ADDENDUM NO. 2 TO PROJECT NO. 47552

ELECTRICAL WORK UPGRADE ELECTRONIC SECURITY SYSTEMS VALLEY RIDGE CIT 274 CHIARINO DRIVE NORWICH NY 13815

November 20, 2024

KEYED NOTES REMOVAL:

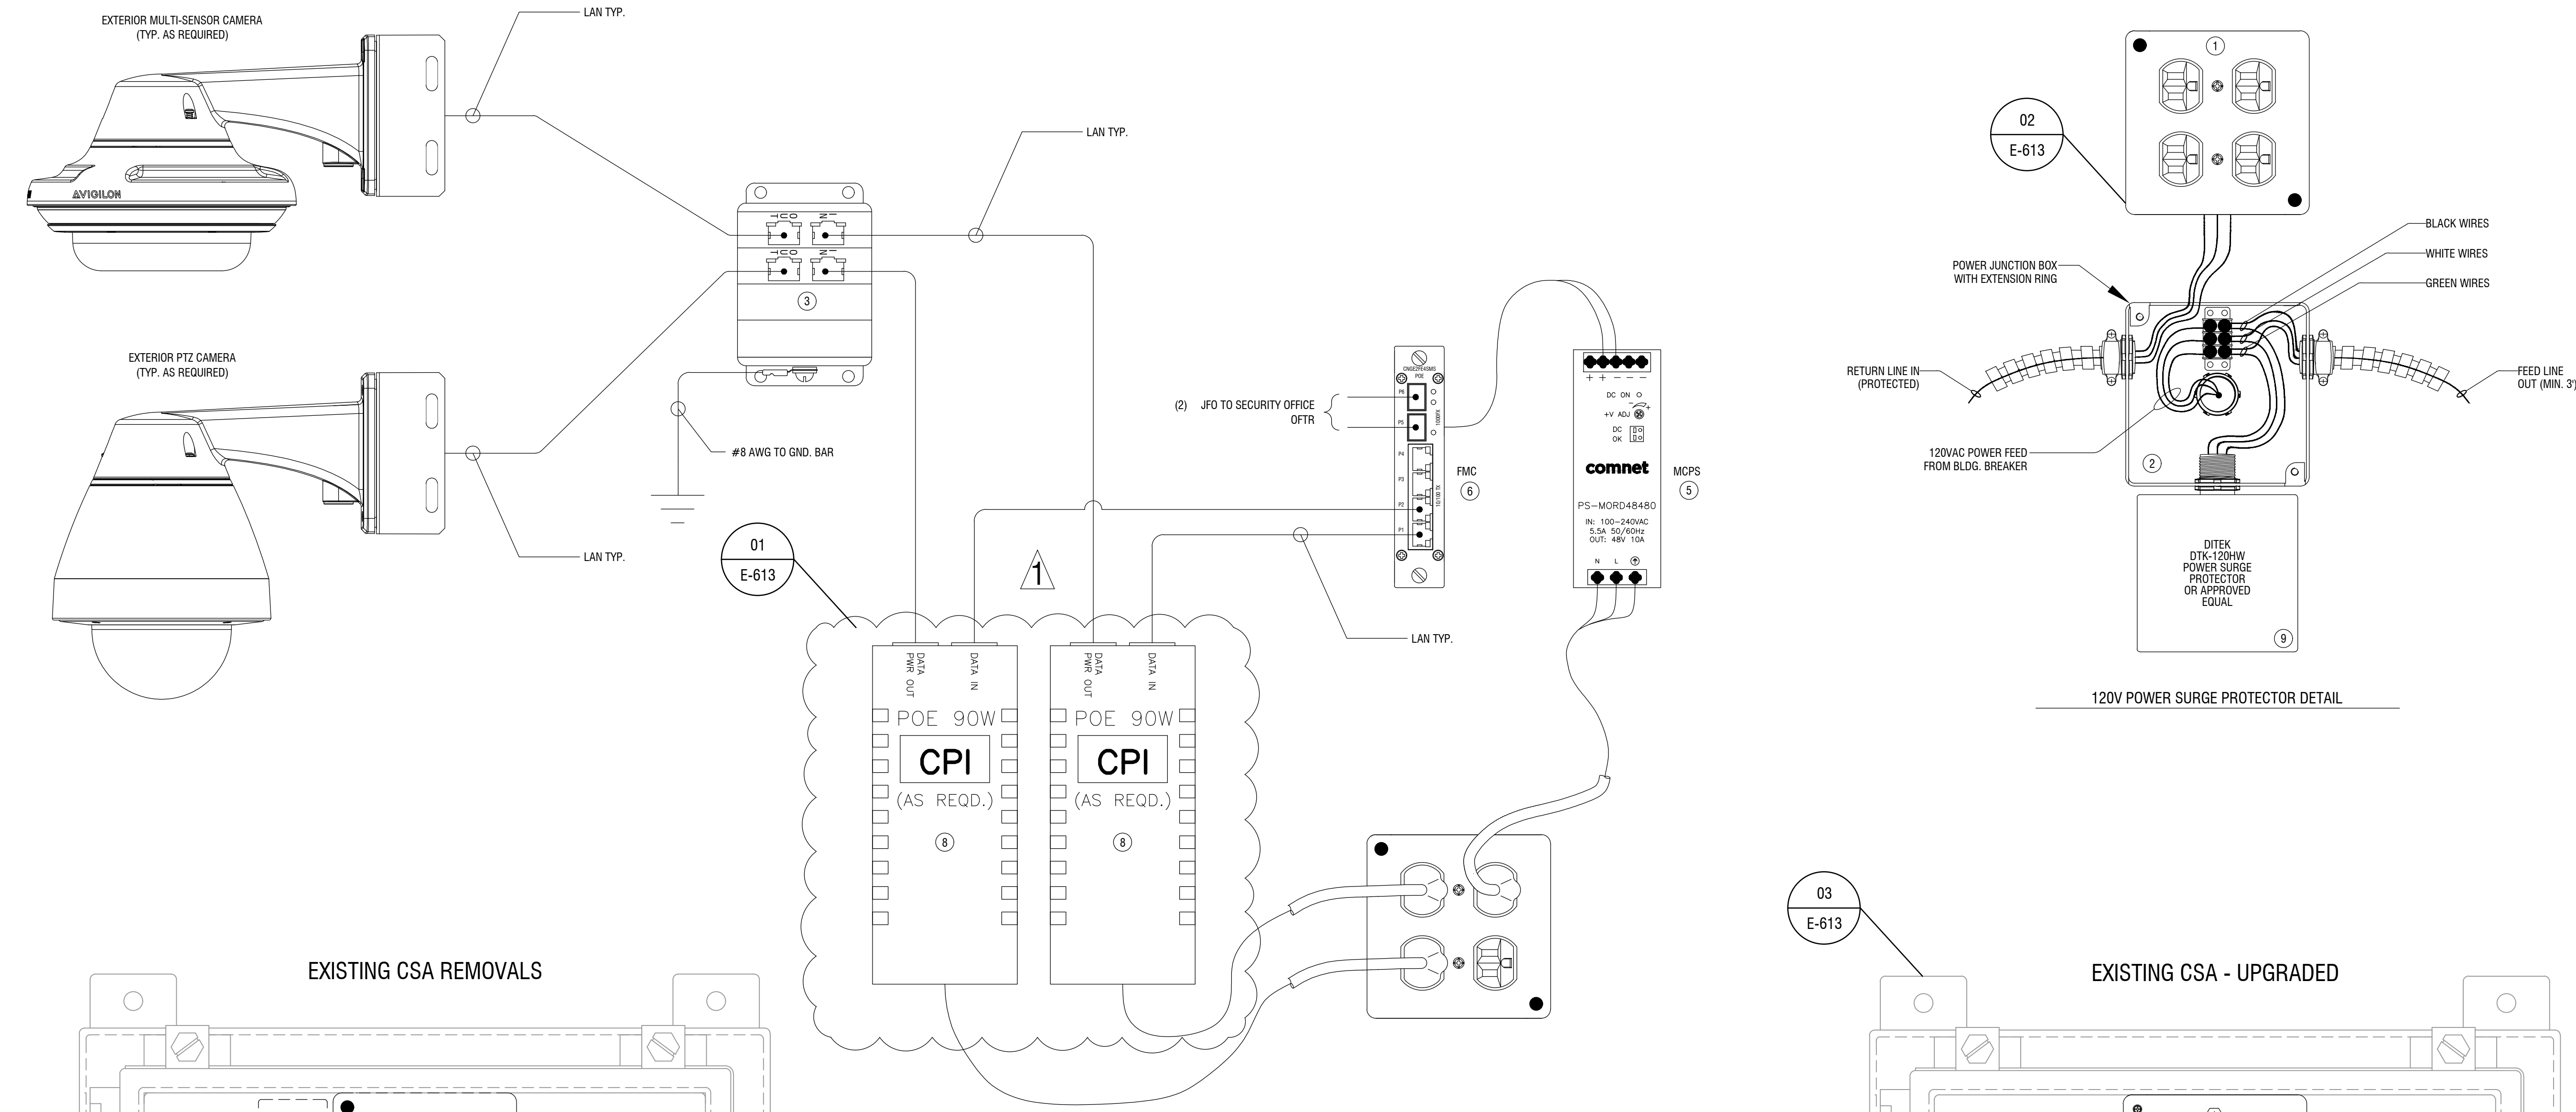
- ① REMOVE EXISTING SINGLE DUPLEX RECEPTACLE AND REPLACE WITH A DOUBLE DUPLEX. ADD 4"x4"x1-1/2" EXTENSION RING FOR CABLING CLEARANCE.
- ② USING THE EXTENSION RING, RUN A 14/3 SOLID BX CABLE AROUND THE INSIDE OF THE ENCLOSURE NO LESS THAN 3". REFER TO POWER SURGE SUPPRESSION DETAIL.
- ③ PROVIDE DITEK DTK-WM4NETS POE SURGE PROTECTOR WITH A MINIMUM OF 2 ACTIVE PORTS.
- ④ PROVIDE 9" 35mm DIN-RAIL CHANNEL.
- ⑤ PROVIDE COMNET PS-MORD48480 POWER SUPPLY FOR NETWORK SWITCH.
- ⑥ PROVIDE COMNET CNGE2FE4SMS NETWORK MODULE. MOUNT SIDWAYS USING THE DINBRK4 MOUNT.
- ⑦ PROVIDE FOUR SCREW DOWN TIE-WRAP HOLDERS. SPACE APPROX. 2" HORIZONTAL AND 4" VERTICAL.
- ⑧ PROVIDE AVIGLON POE-INJ2-95W-NA POWER INJECTOR. RESERVE SPACE FOR 2ND OR FUTURE UNIT.
- ⑨ PROVIDE DITEK DTK-120HW POWER SURGE SUPPRESSOR.
- ⑩ PROVIDE COMNET PS-AMR2-24 POWER SUPPLY FOR ELPAS ELC ANTENNA.

PROJECT NUMBER:	47552 - E	
DESIGNED BY:	MJP	
DRAWN BY:	MJP	
FIELD CHECK:		
APPROVED:	NCH	
SHEET TITLE:	PROGRAM BUILDING SECURITY OFFICE RACK A-F ELEVATION	
DRAWING NUMBER:	E-730

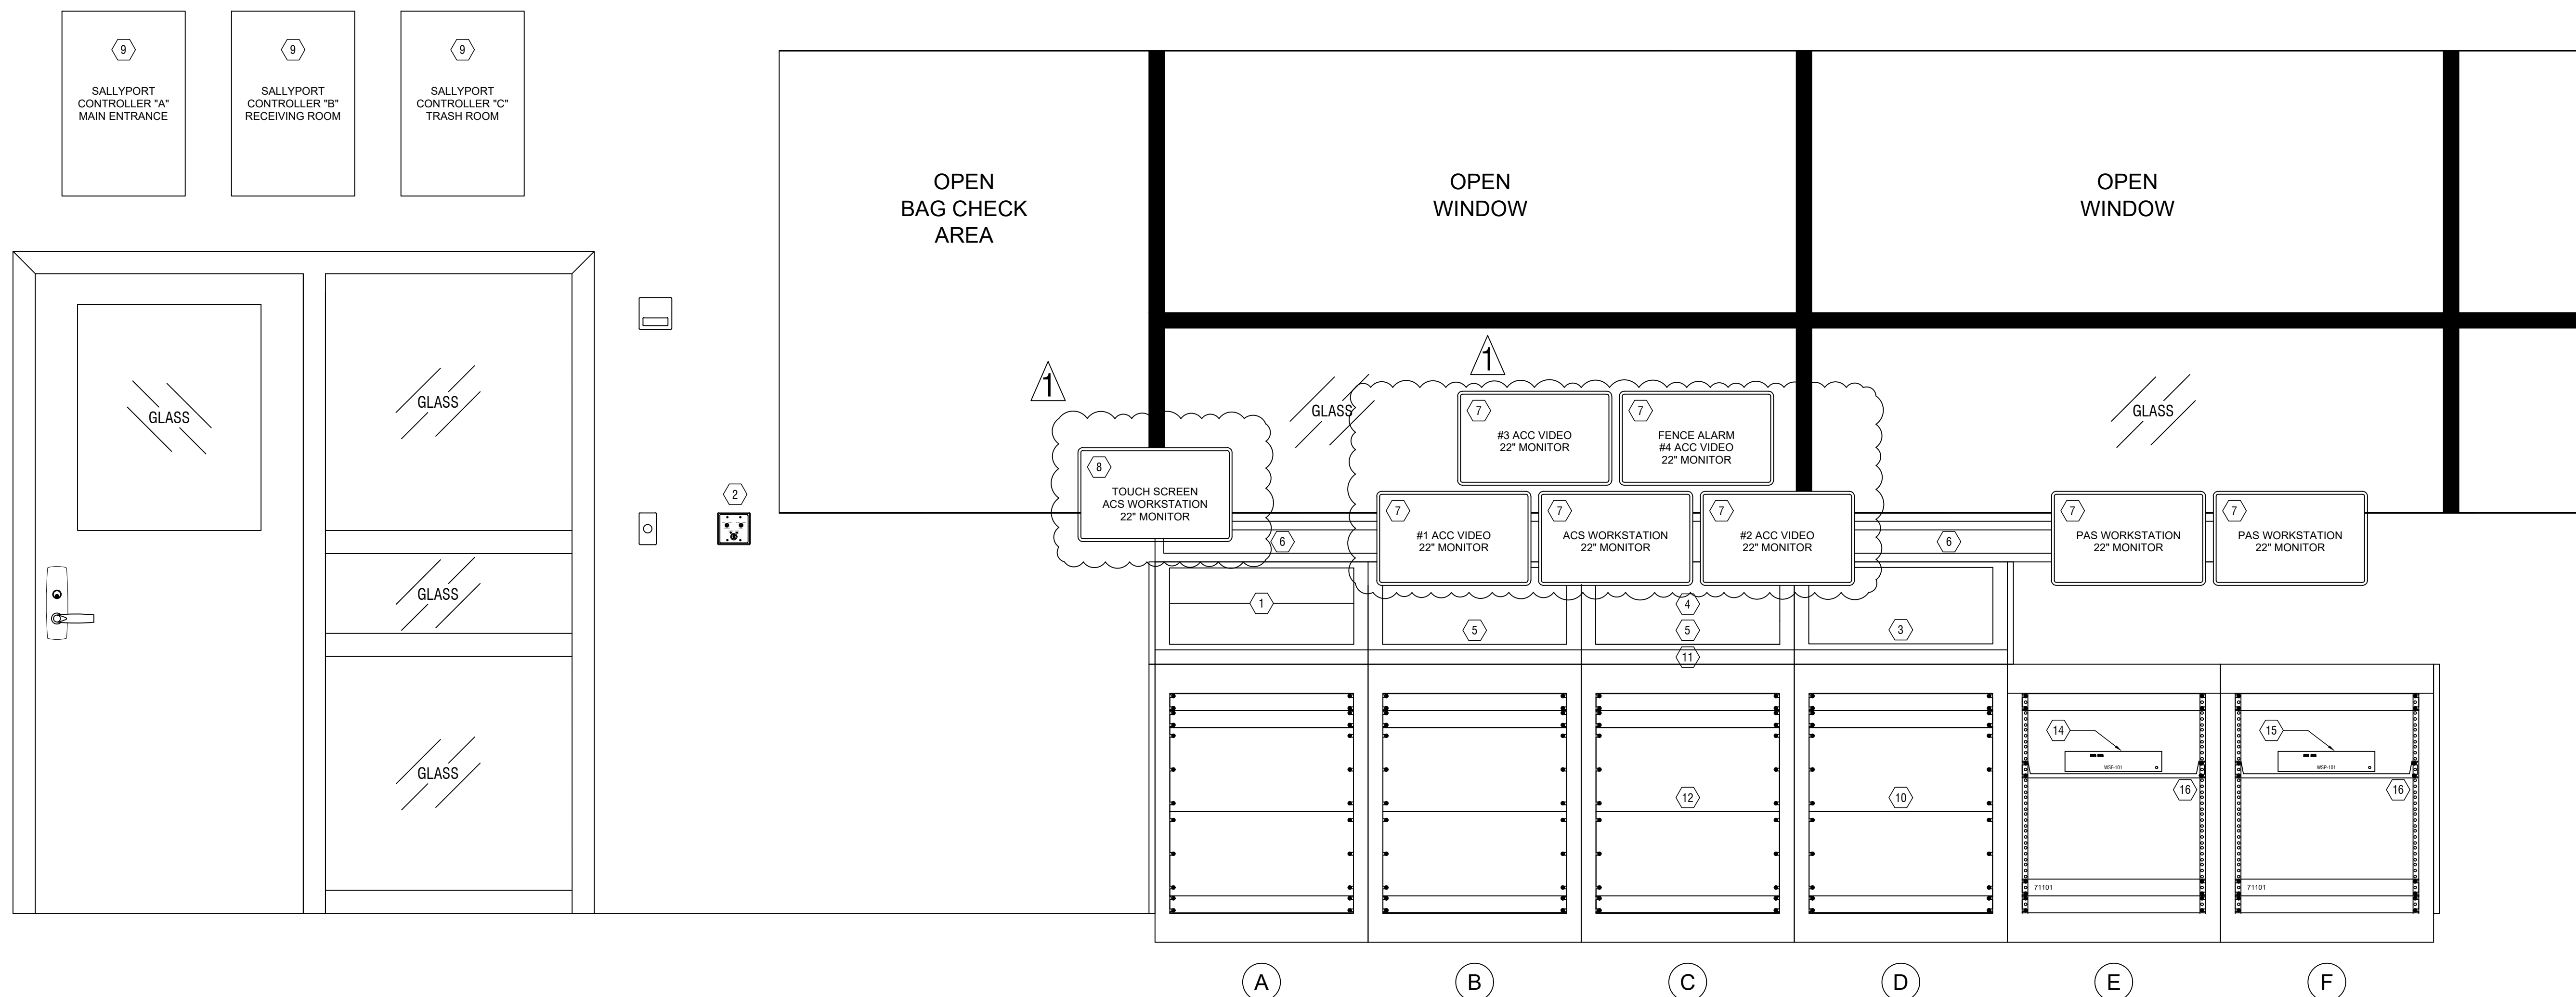
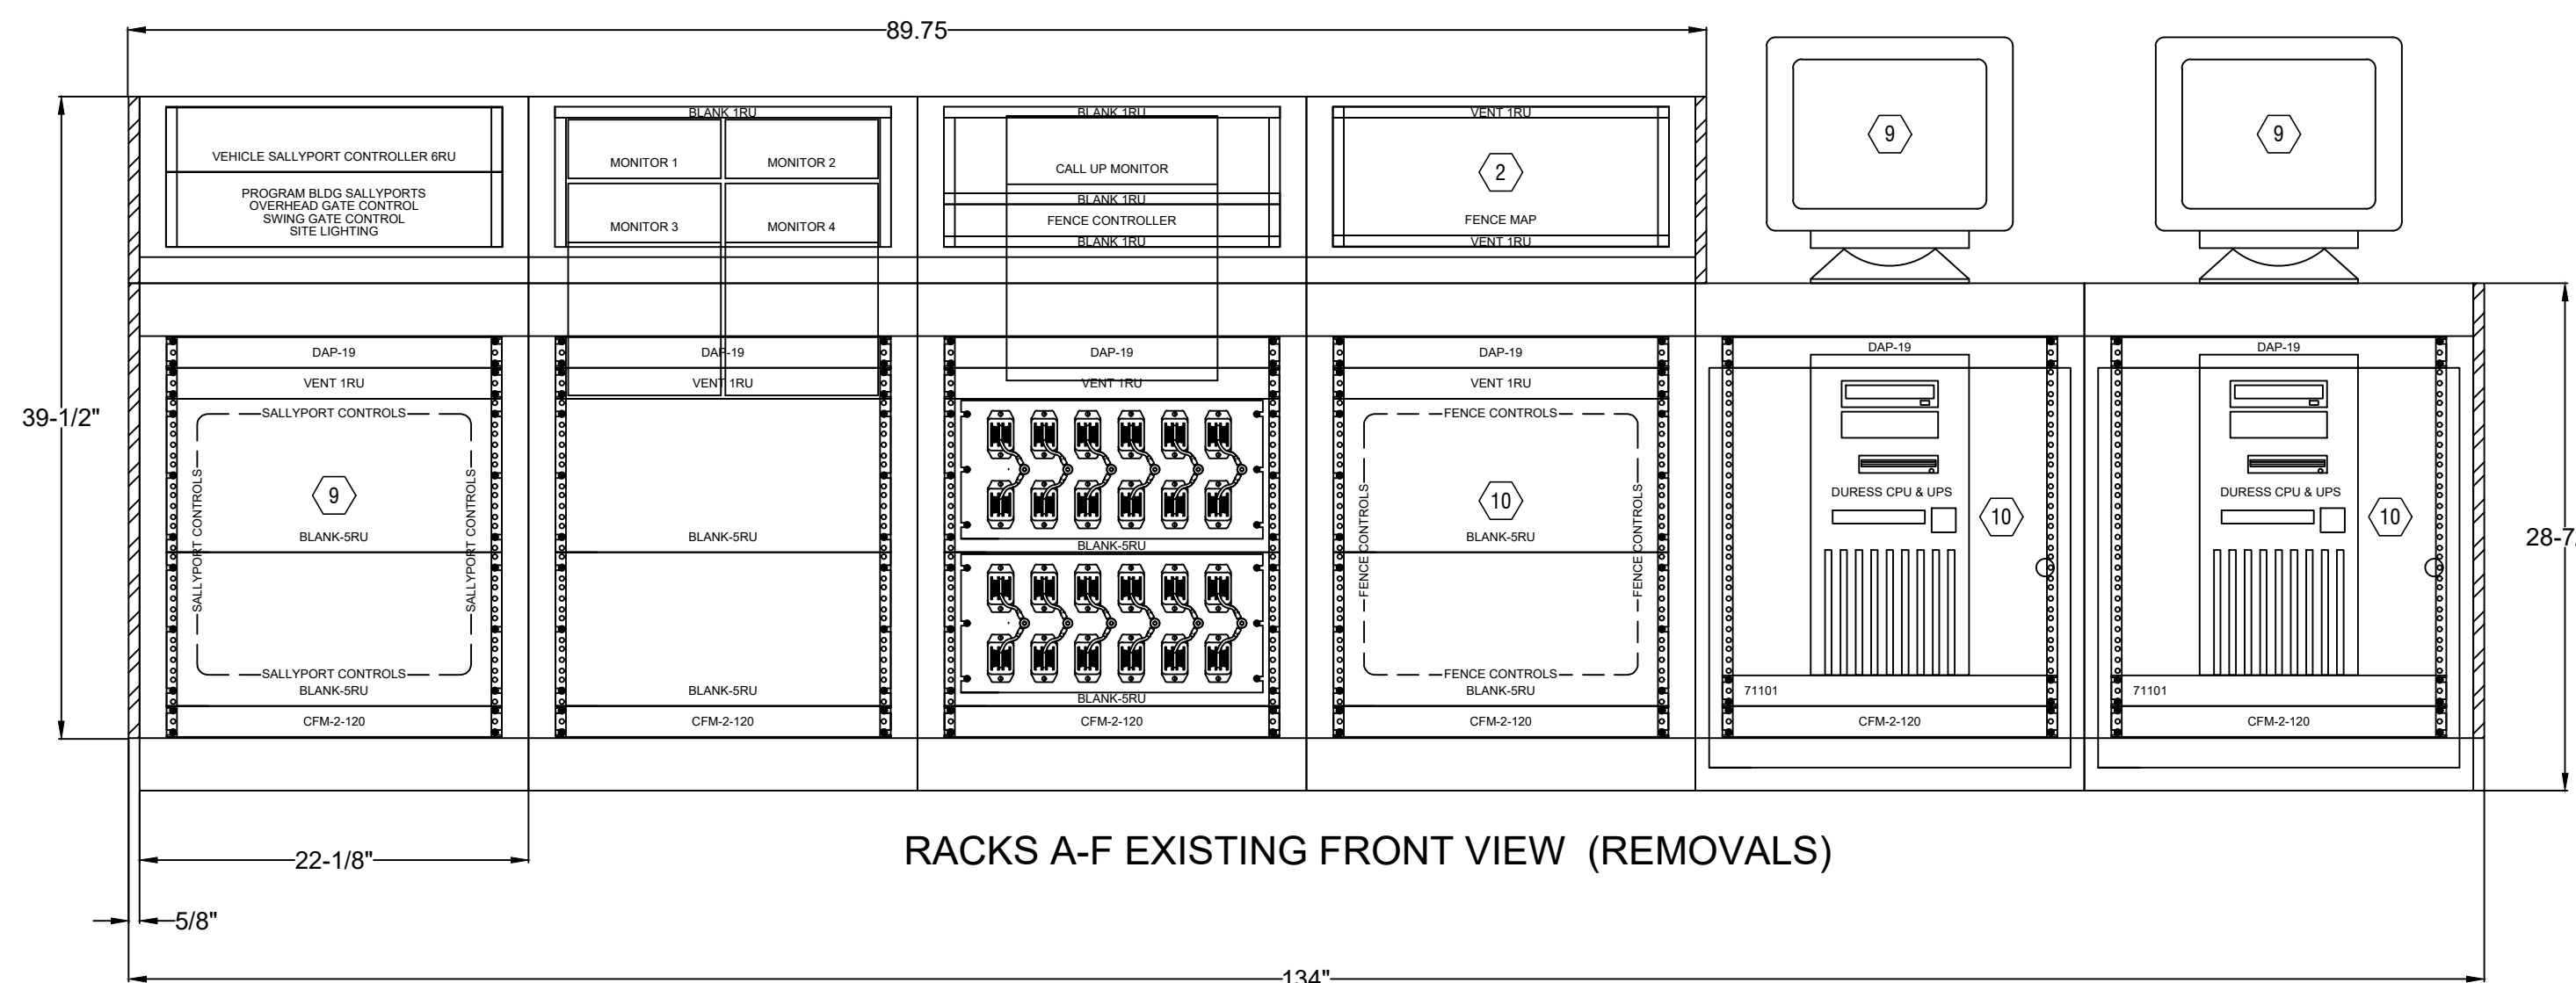
- 1 CONTRACTOR TO PROVIDE SALLYPORT AND GATE CONTROL CONSOLE AND MAINTAIN ALL EXISTING FUNCTIONALITY.
- 2 CONTRACTOR TO PROVIDE MAIN ENTRANCE SALLYPORT SUB-PANEL ON WALL MATCHING THE HEIGHT OF THE LIGHT SWITCH.

- 3 CONTRACTOR TO REMOVE PERIMETER FENCE DETECTION GRAPHIC MAP. PROVIDE PERIMETER FENCE ALARM PC MONITOR. PROVIDE BLANK PANEL.
- 4 CONTRACTOR TO REMOVE PERIMETER FENCE DETECTION CONTROLLER AFTER CONSTRUCTION AND PROVIDE BLANK PANEL.

- 5 CONTRACTOR TO REMOVE ANY EXISTING CRT MONITORS AND REPLACE WITH BLANK PANEL.
- 6 PROVIDE WALL MOUNTED TRACK FOR MULTIPLE MONITOR CONFIGURATIONS. TRACK WILL ALLOW MONITORS TO ADJUST VERTICALLY AND HORIZONTALLY ALONG THE WALL.

- 7 PROVIDE 22" TRACK MOUNTED SECURITY MONITORS AS LABELLED.
- 8 RECENTLY UPGRADED TOUCH SCREEN MONITOR TO REMAIN.
- 9 CONTRACTOR TO REMOVE OLD SALLYPORT CONTROLLERS FROM UNDER BASE CABINETS. USE ENCLOSURES TO HOUSE TERMINAL STRIPS TO EXTEND THE CABLE TO THE NEW SALLYPORT CONTROLLERS MOUNTED IN SECURITY OFFICE ABOVE SALLYPORT DOOR.

- 10 CONTRACTOR TO REMOVE EXISTING PAS WORKSTATION AND MONITOR ONCE PAS SYSTEM HAS BEEN PROVIDED AND ACCEPTED.
- 11 CONTRACTOR TO REMOVE FENCE ARI (RELAY CONTROL) AND ALL CABLING AFTER EXISTING PERIMETER 7000 HAS BEEN REMOVED AND FLEXZONE SYSTEM IS COMPLETED ON PERMANENT FENCE.

- 12 CONTRACTOR TO REMOVE CCTV JOYSTICK AFTER ALL CAMERAS ARE PROVIDED AND OPERATIONAL.
- 13 LIGHTNING SURGE SUPPRESSORS WILL REMAIN. CABLING FOR FOR EXTERIOR SPEAKERS WILL REMAIN. CONTRACTOR TO REMOVE ANY REMAINING INTERCOM CABLING FOR ANALOG INTERCOMS.

- 14 PROVIDE PERIMETER FENCE WORKSTATION AND MONITOR FOR SENSTAR PERIMETER FENCE SYSTEM. NETWORK MANAGER SOFTWARE WILL COMMUNICATE DIRECTLY WITH AVIGILON SOFTWARE VIA ACII TEXT.

- 15 PROVIDE CENTRAK PERSONAL ALARM WORKSTATION AND MONITOR.
- 16 PROVIDE SHELF FOR THIN CLIENT WORKSTATION.
